Additions and/or changes:

Figure 1 – Array shown with 2 subs behind primary array

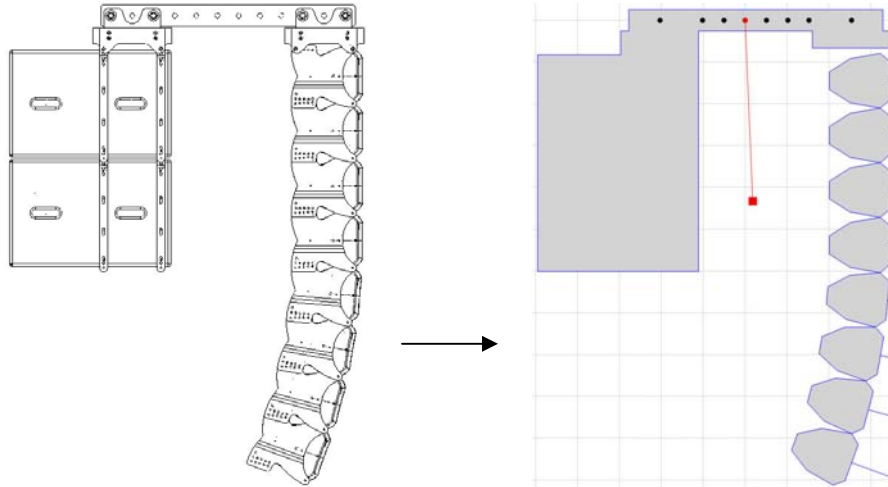
1. Added frame configurations with 1 to 4 subs (WL115-sw) behind primary array. Note that 1 extension bar (EB2082-i) and 2 array frames (FB2082-i) are required for these configurations. See figure 1 for sample representation.
